**Wisconsin Owner, LLC
(Urban Investment Partners)
4620-24 Wisconsin Avenue
ZC No. 16-26**

Tenleytown Neighbors Association

ZONING COMMISSION 1
District of Columbia
CASE NO.16-26
EXHIBIT NO.50

POSITION STATEMENT

NORTH ELEVATION

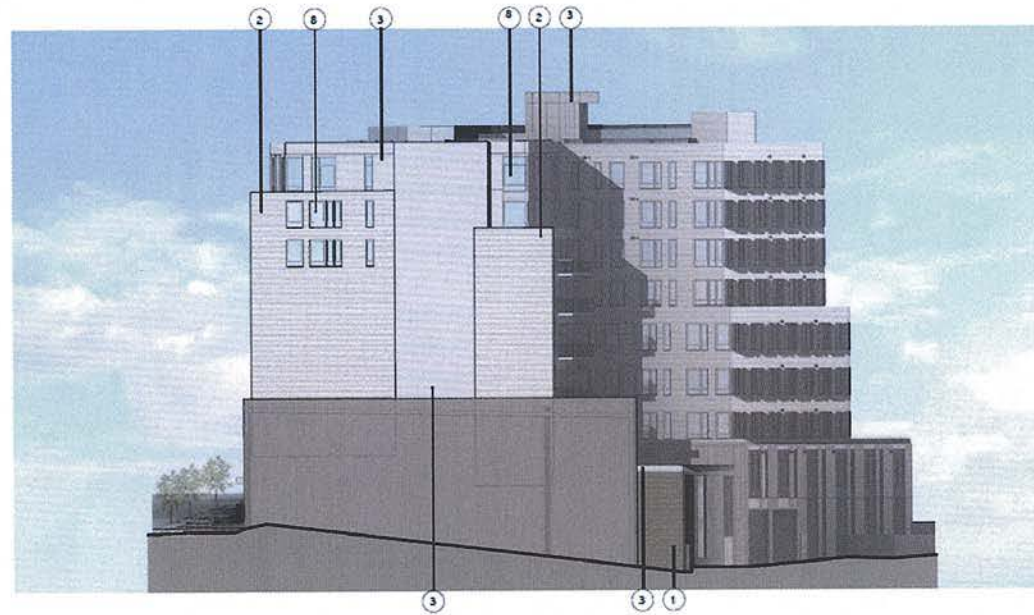
UIP North View: No Step Down

- ▶ The UIP project would be built on one of the highest hills in DC and on land that slopes down hill to the north (10 ft.) and west (12 ft.).
 - The building would not step down along Wisconsin Avenue to adjust to the change in elevation as current buildings do. **On the contrary**, it is two stories taller than Tenley View to the south and rises to 93 ft. at north end.
 - The west façade facing residential areas is 103 ft. high with a **set back of only 3 ft.** for top half of the structure, thus confronting residents with a monolithic wall.
 - UIP requests relief to allow **89.9% Lot Occupancy** leaving little space for transition to residential areas.

UIP Proposal is higher/more dense than nearby ZC Approved Projects

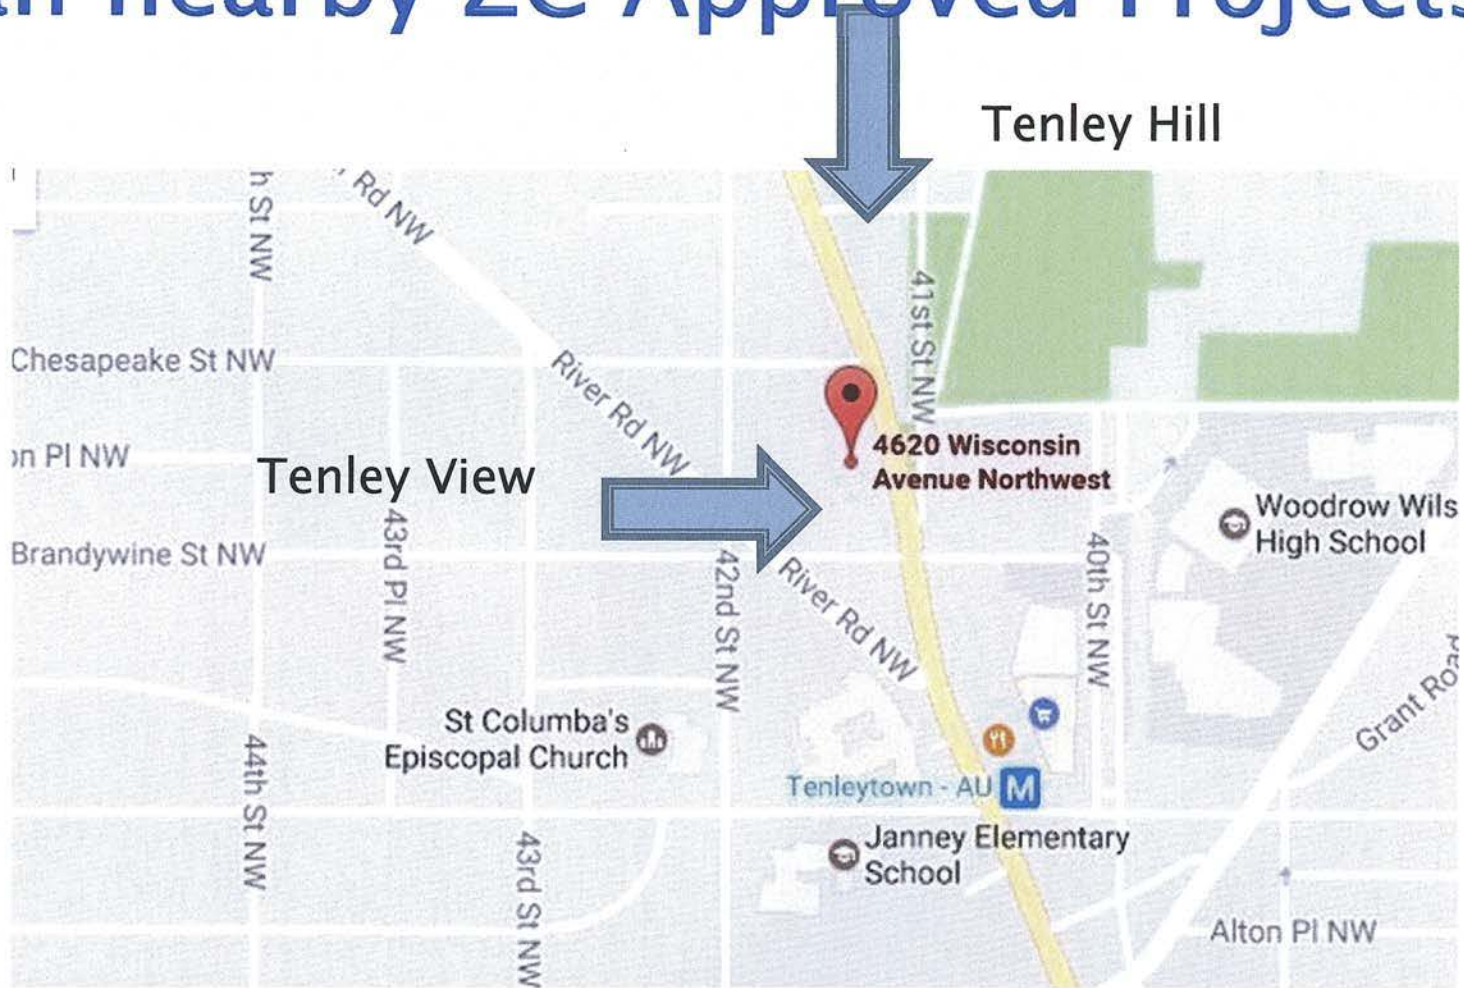
- UIP project is comparable in land area to Tenley Hill but is higher (+36%) and more dense (+27%).
- UIP would offer predominately studio units; Tenley Hill offers multi-bedroom units and townhouses that transition to nearby low-rise, residential area.

How does UIP at 88ft (103ft at highest) compare to nearby development. This is Tenley Hill, 4725 Wisc Av. Height 65 ft. But Tenley Hill “steps down” to townhouses when near family homes.
